Additional comments will be provided regarding items added or altered after the initial submittal.

SCHMIDT PARCEL

EL PASO COUNTY

PLANNED UNIT DEVELOPMENT PLAN & PRELIMINARY PLAN

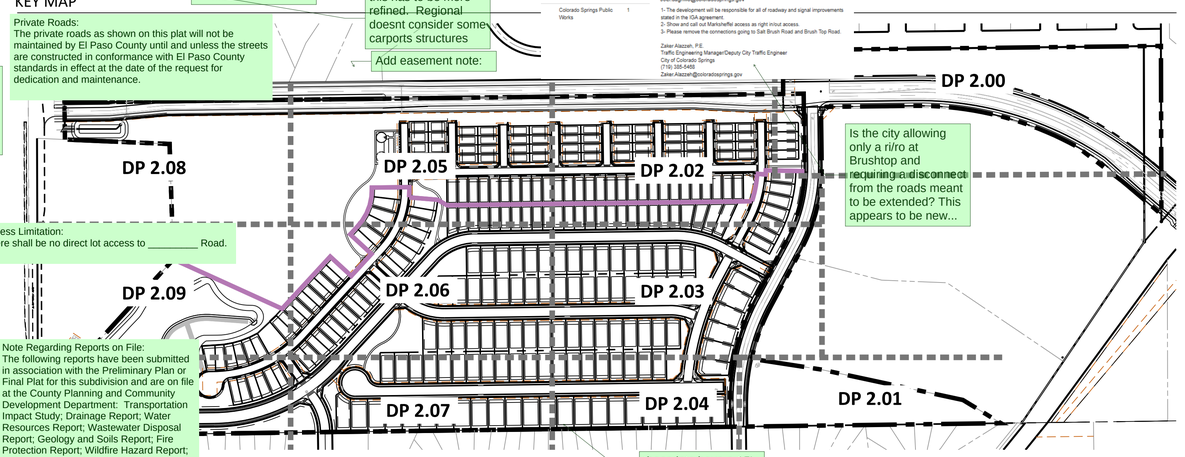
Provide a vicinity for prelim area verses PUD zoning area only. Some of the Prelim is to remain what zone?

Concur with Traffic Engineering comment:
The development will be responsible for all of roadway and signal improvements stated in the IGA agreement. Please submit separate construction plan drawings to the City showing for all Marksheffel Rd. public improvements.

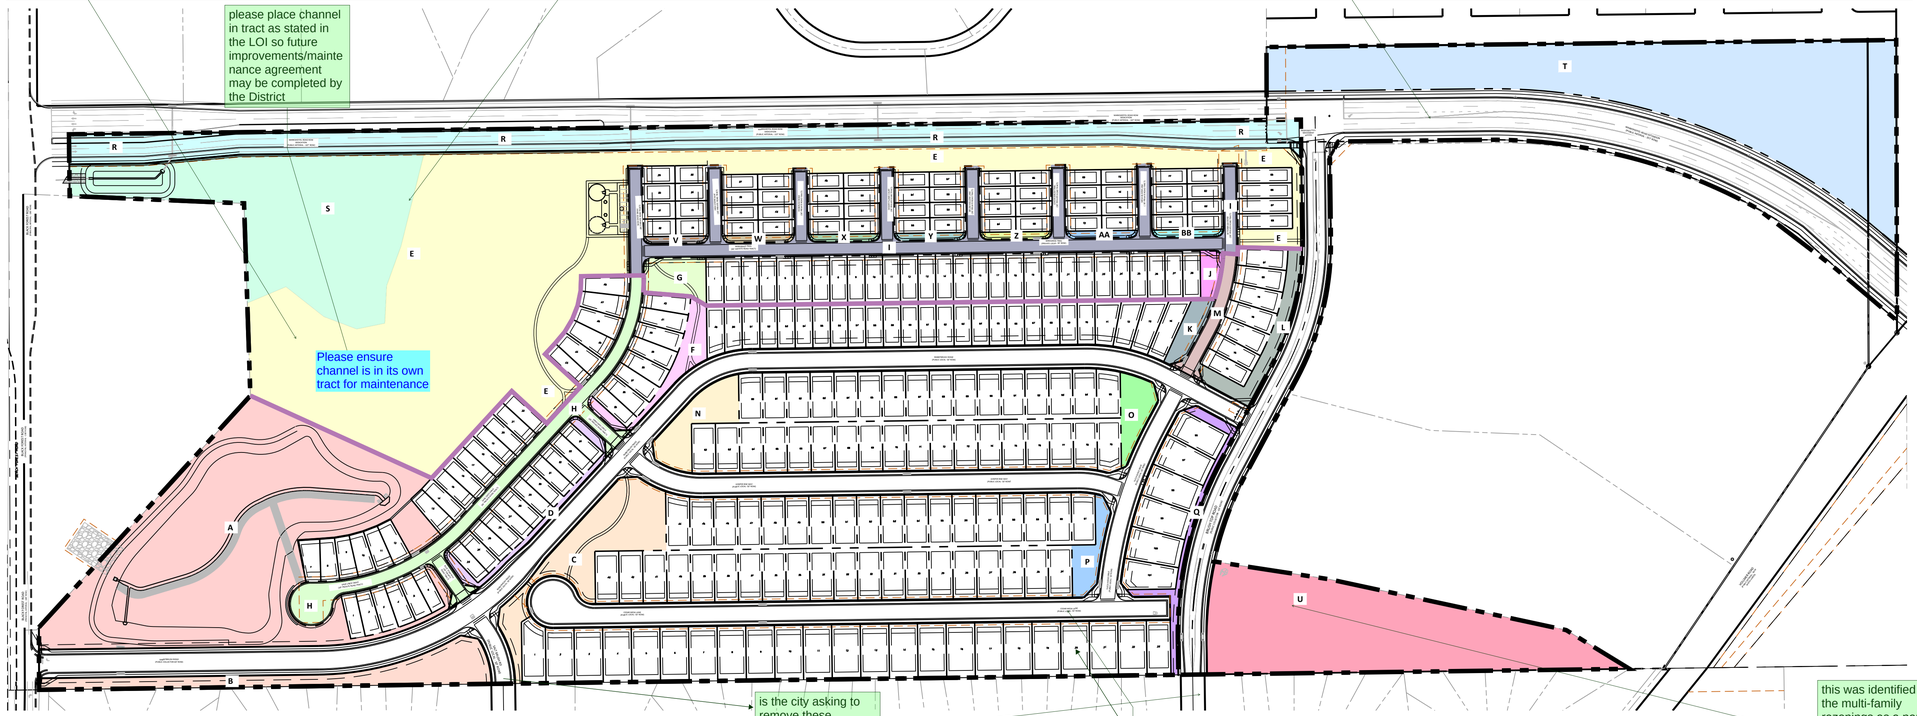
open space is not the same as landscape nor parkland

how can a metro district own the future dev tracts? that is not within a districts purview.

i believe you will have a tract for the Prelim plan and a tract for the PUD since the Prelim will have future dev tracts. Would it be better to include all in the PUD as future development tracts to be rezoned.

road labels

Provide the tract table, SF, use, ownership and maintenace

is the city asking to remove these connections? That is a new path- perhaps a meeting to dicuss?

this was identified in the multi-family rezonings as a part of that MF rezoning buffer to adj Please remove this from the OS count.

DUPLEX PLANS

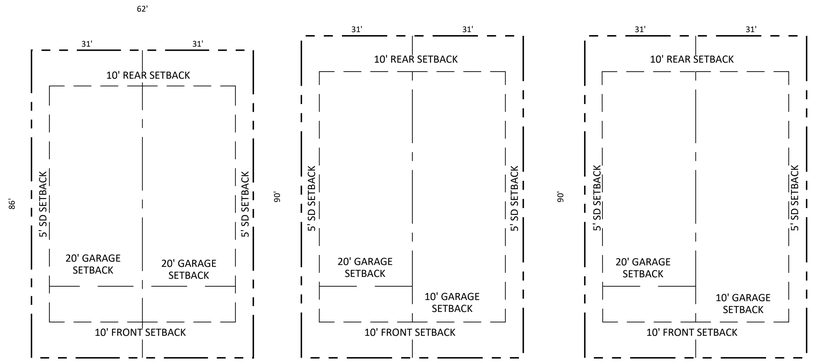
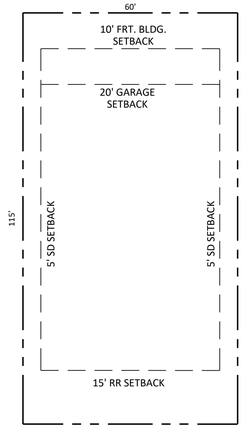
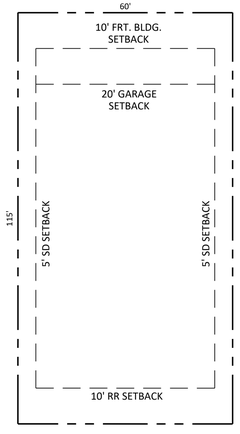
maybe add the development standards and PUD guidelines for each here, but still staff will have no idea which lots these apply to without lot numbers or sizes.

are these 2 attached sf units on one lot? or are these 2 lots? where are the easements, where is the driveway and back of curb and sidewalk? please look st PUDSP examples provided and update details all pages for lot typicals. Add the lot numbers to these.

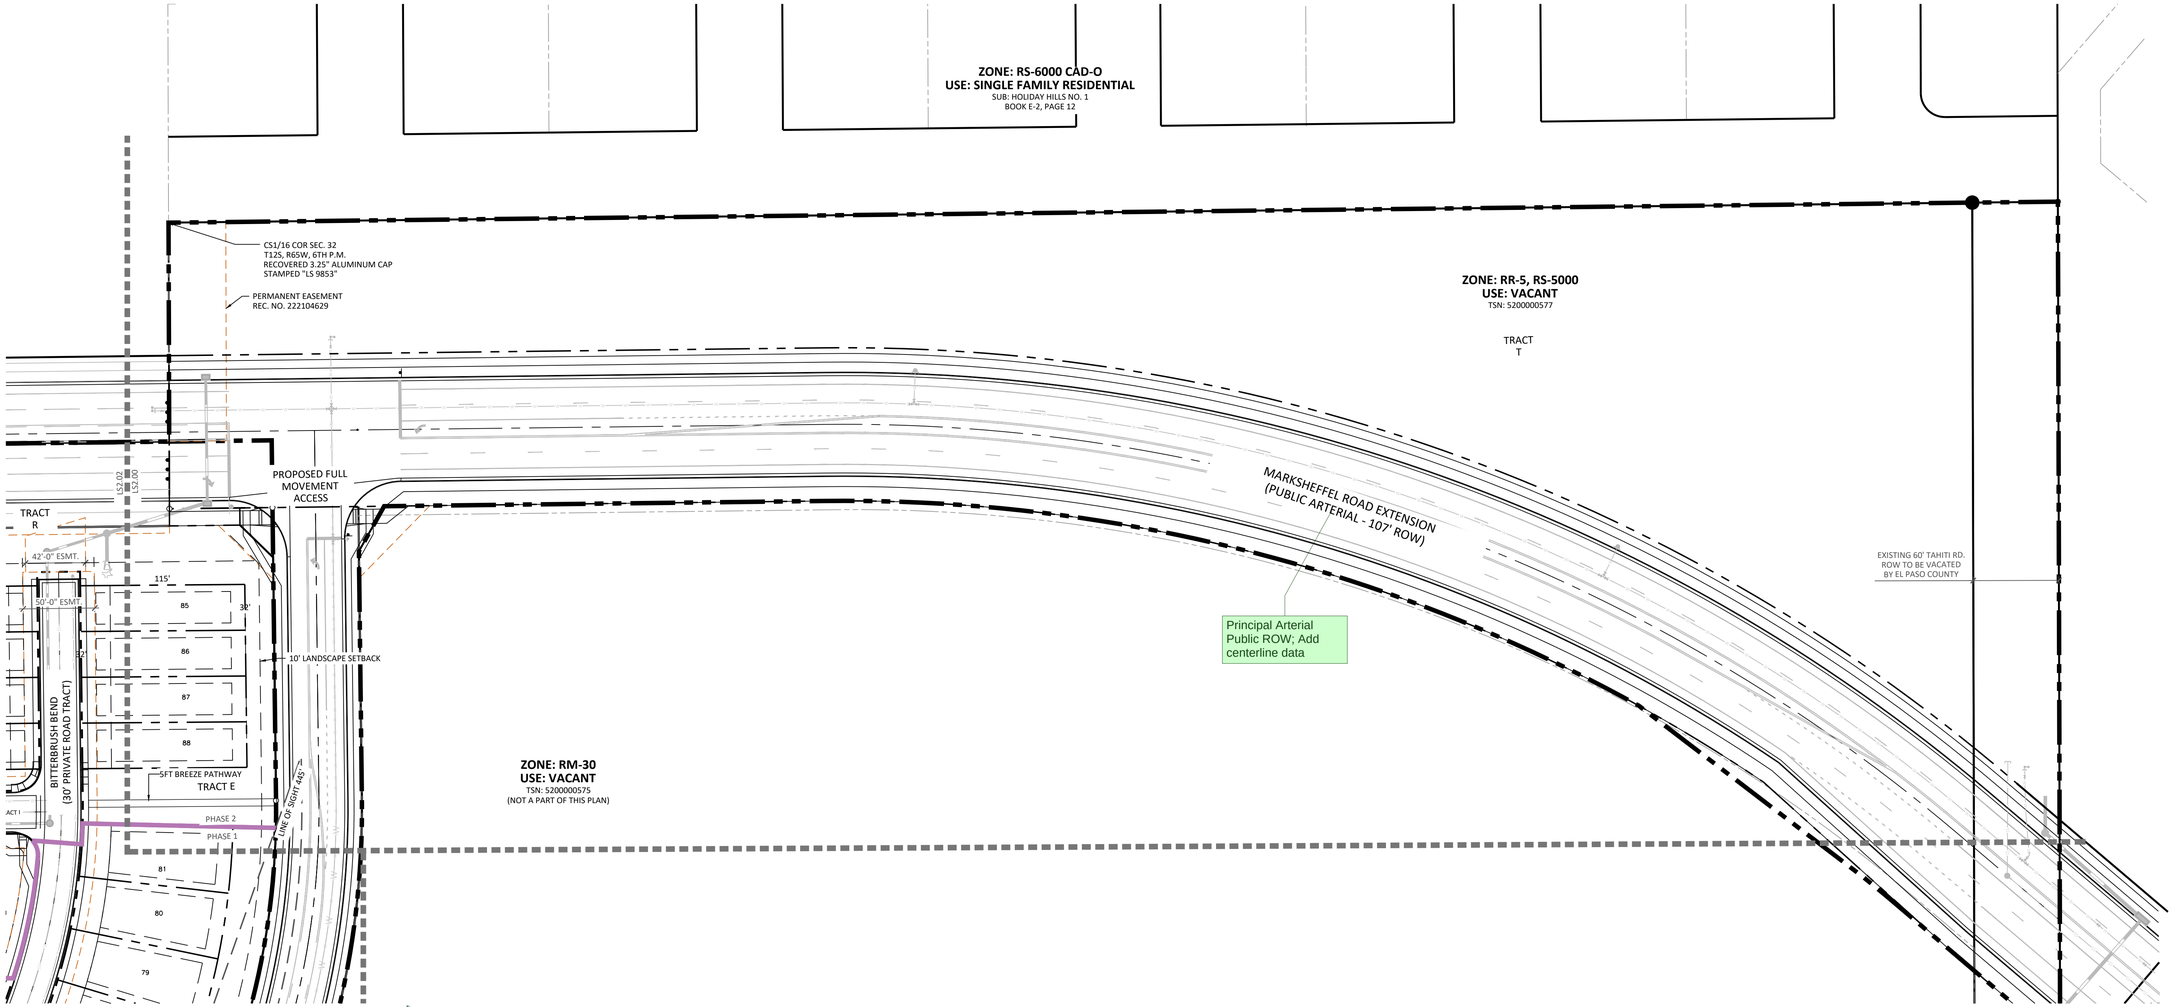
Principal Arterial
Public ROW; Add
centerline data

please review PUD and Preliminary Plan checklists and add missing info.

COTTONWOOD CREEK (HAS FLOODPLAIN)

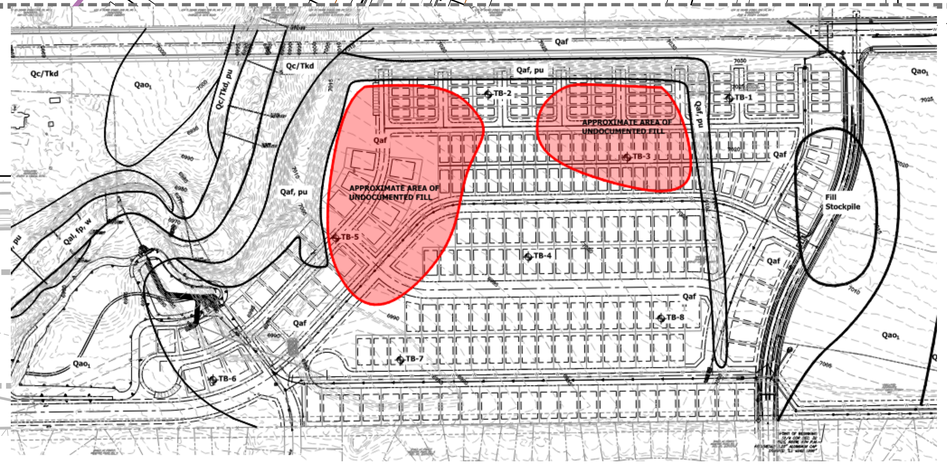
identify the creek, floodplain and BE

identify no build area for wetlands and natural areas to be preserved. Per Chapater 8 of the code. Is the applicant required to stabilize any part of the channel?

acerages or sf

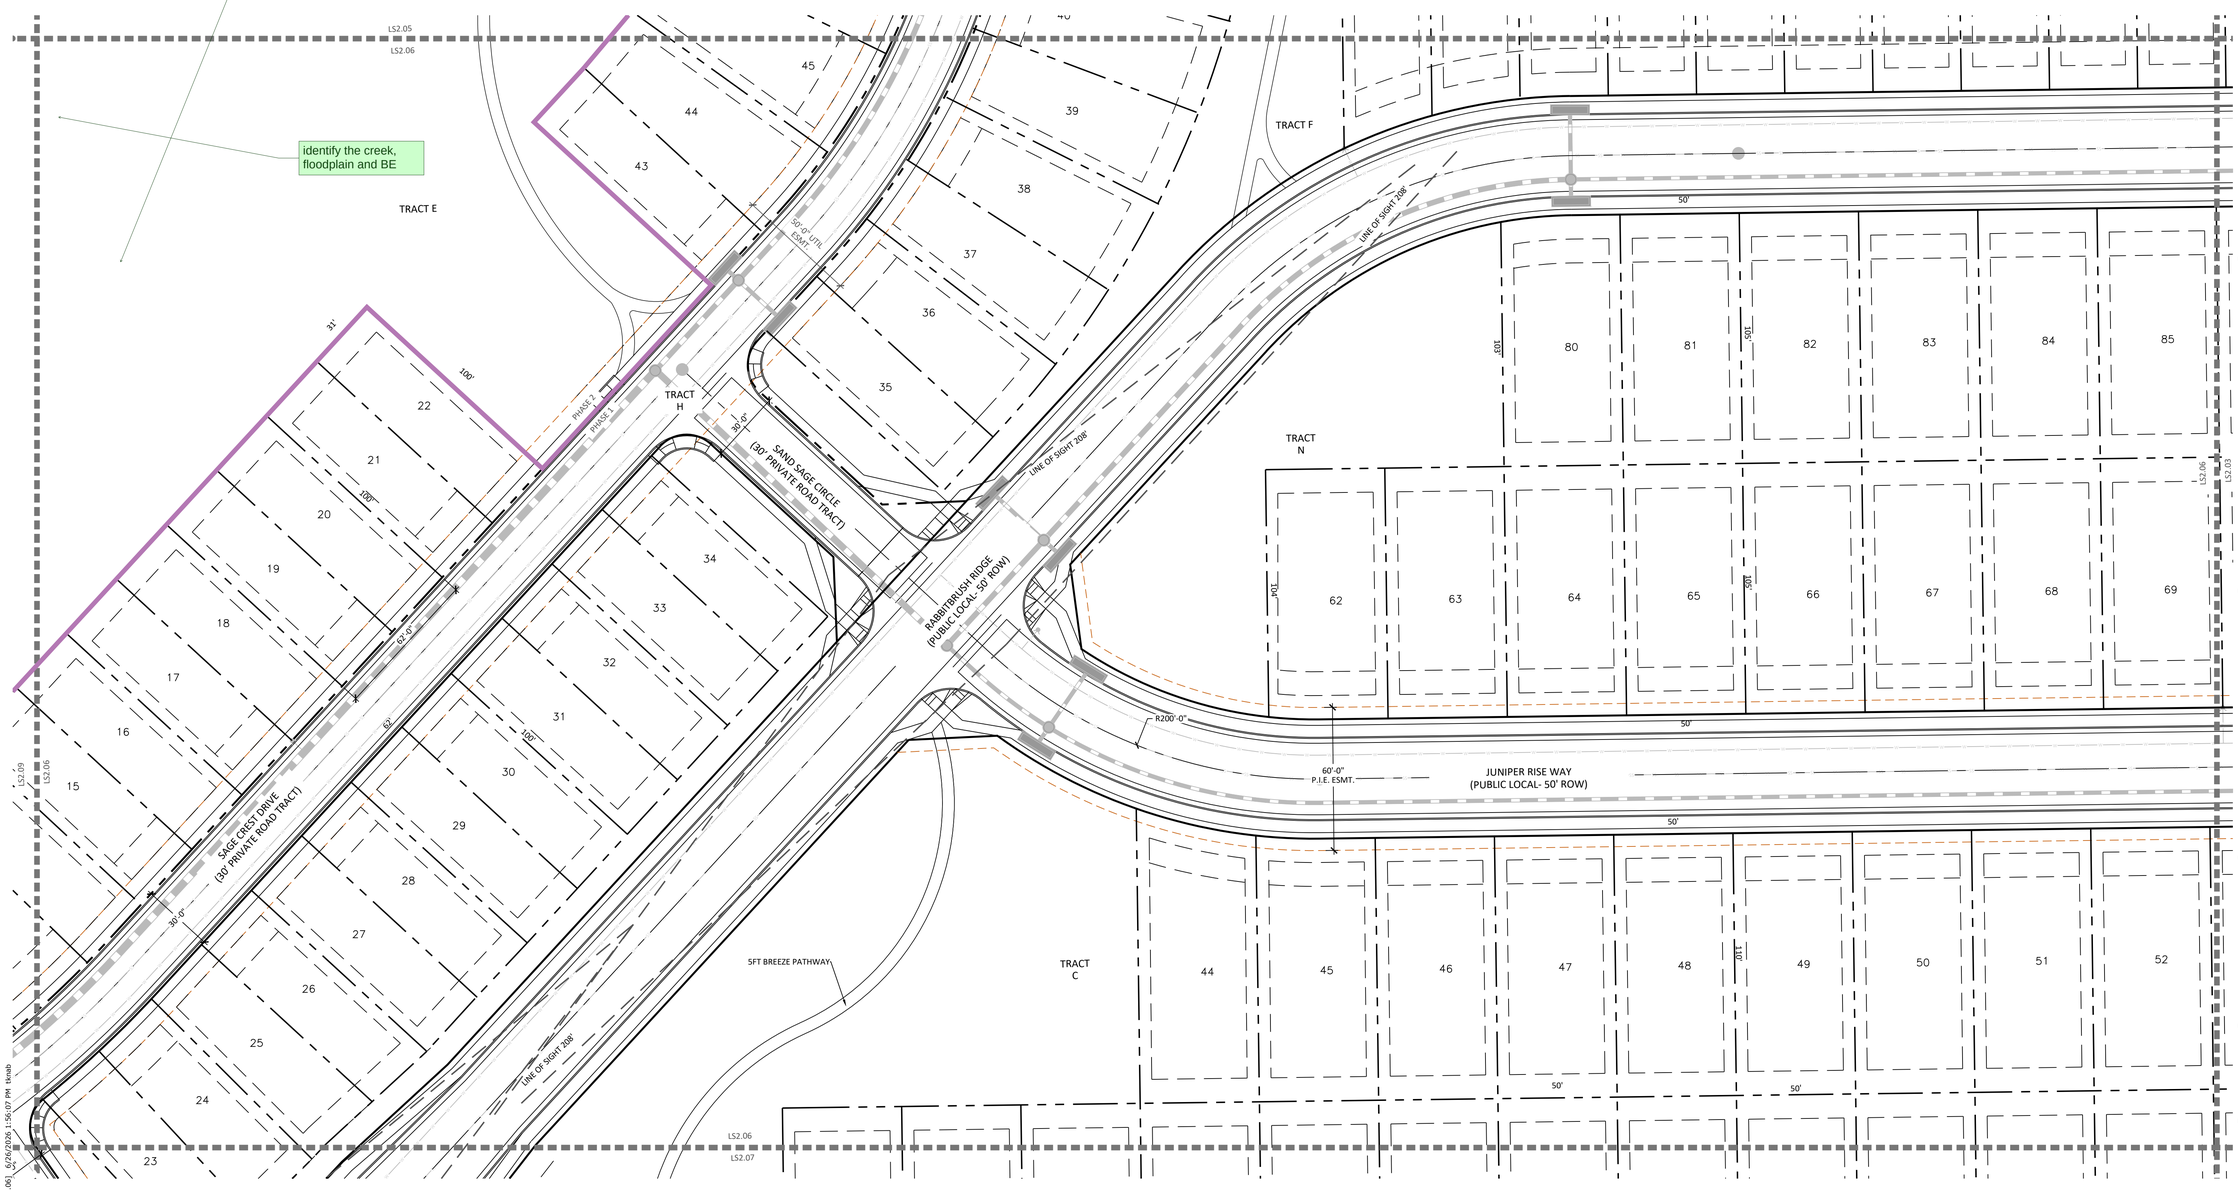
identify the creek, floodplain and BE

PUD Dev Plan & Preliminary Plan? Lot layout?

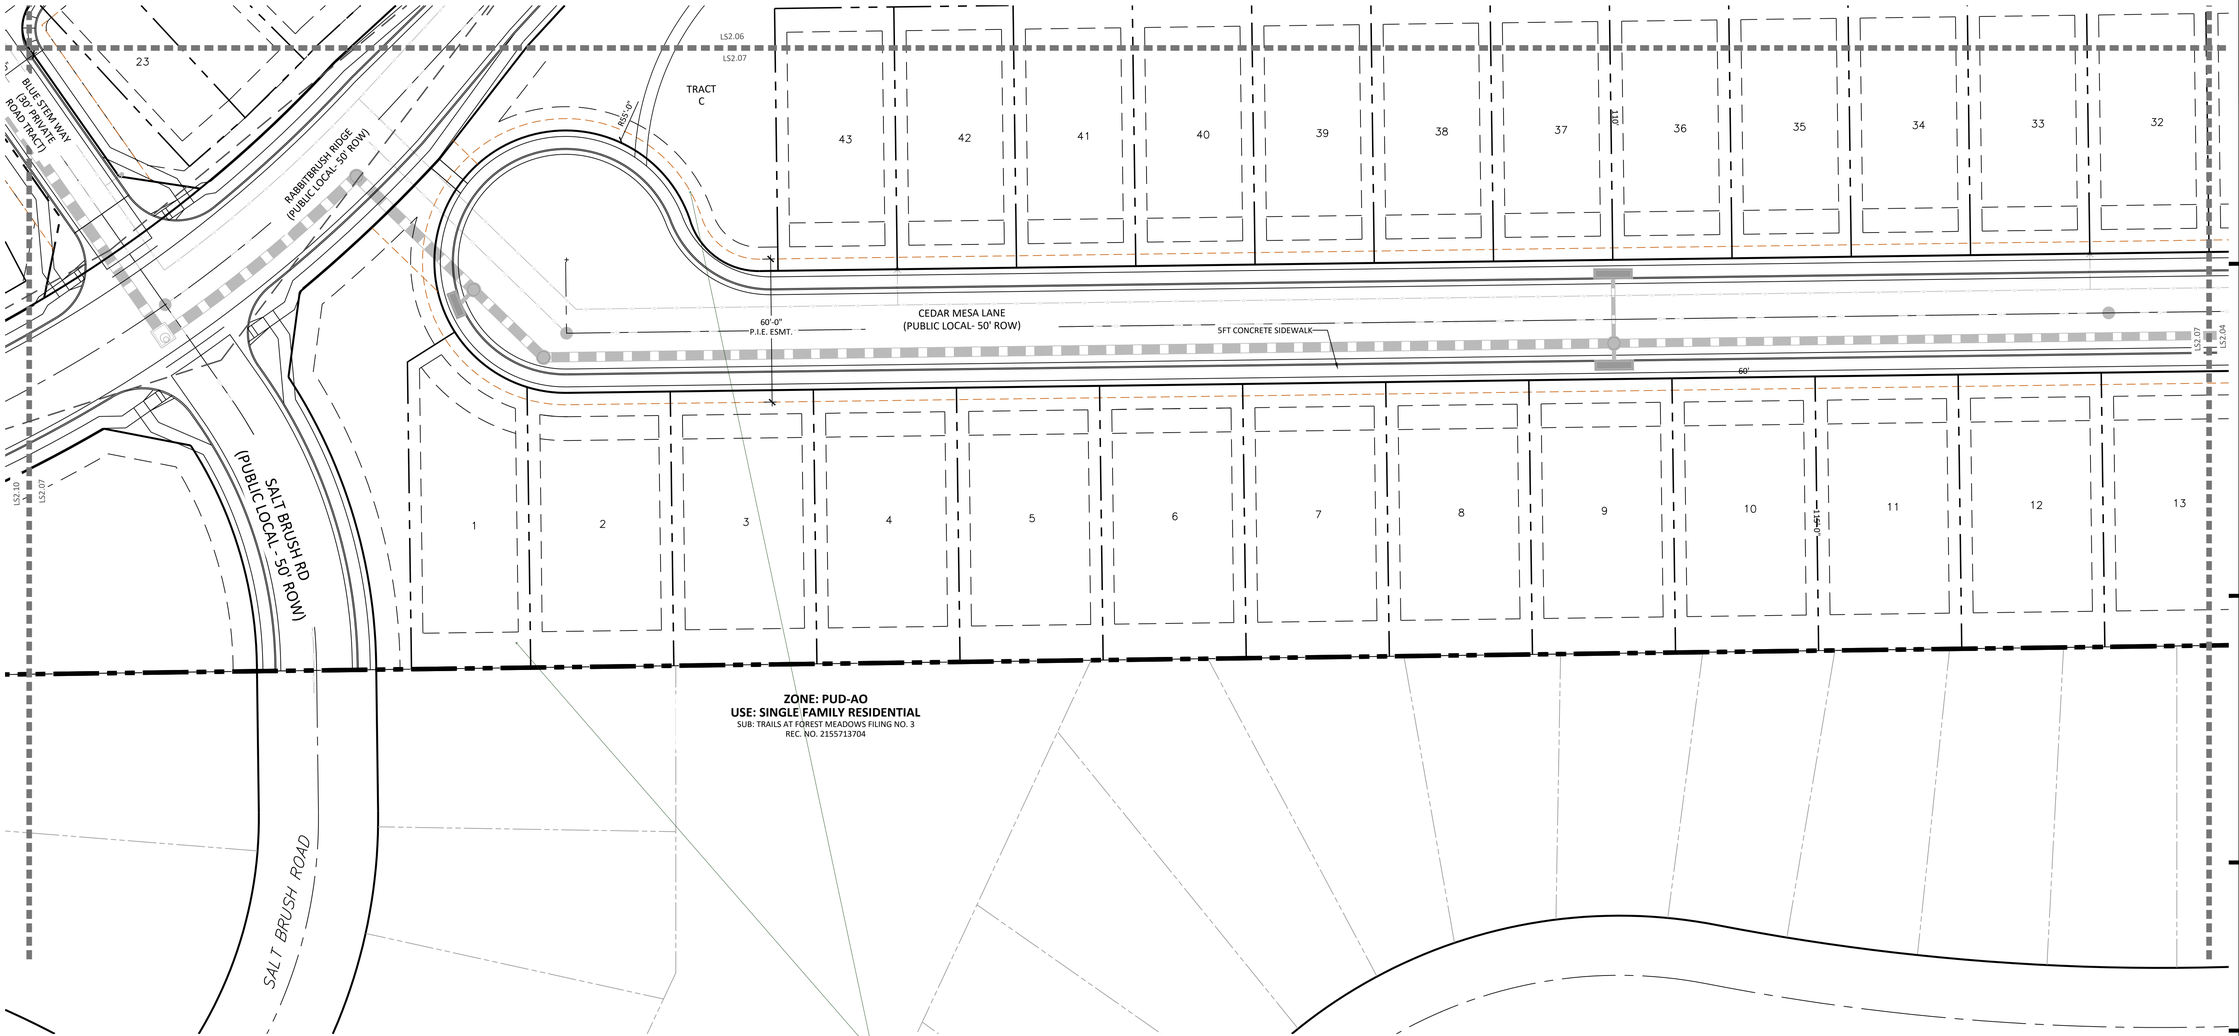
do we need parking spaces here for this large open space area?

A buffer is apprpriate here as there are 2 lots to 1-doubling density
